# **DESK PACKET**

Bidarki Creek No. 5; KPB File 2022-160
 Orion Surveys / Lamb & Reilly
 Location: Near MP 171 Sterling Highway
 City of Homer

# Subdividers response to petitions for review of plat approval of Bidarki Creek 5, KPB File No. 2022-160 by the Kenai Peninsula Planning Commission, Plat Committee.

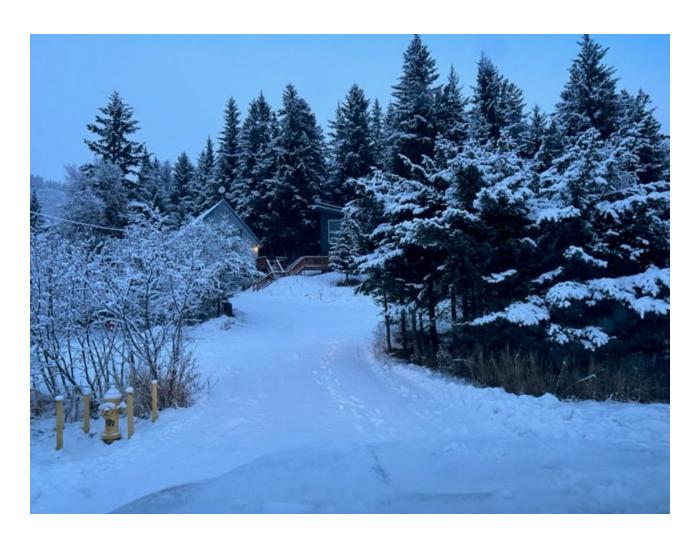
picture front of property

Ariel view

3 flag lots next to Bidarki Creek?

Code 20.30.040

The character of this property will be severely damaged Full stand of mature trees. Would like defined to meet this code. Code 21.18.081
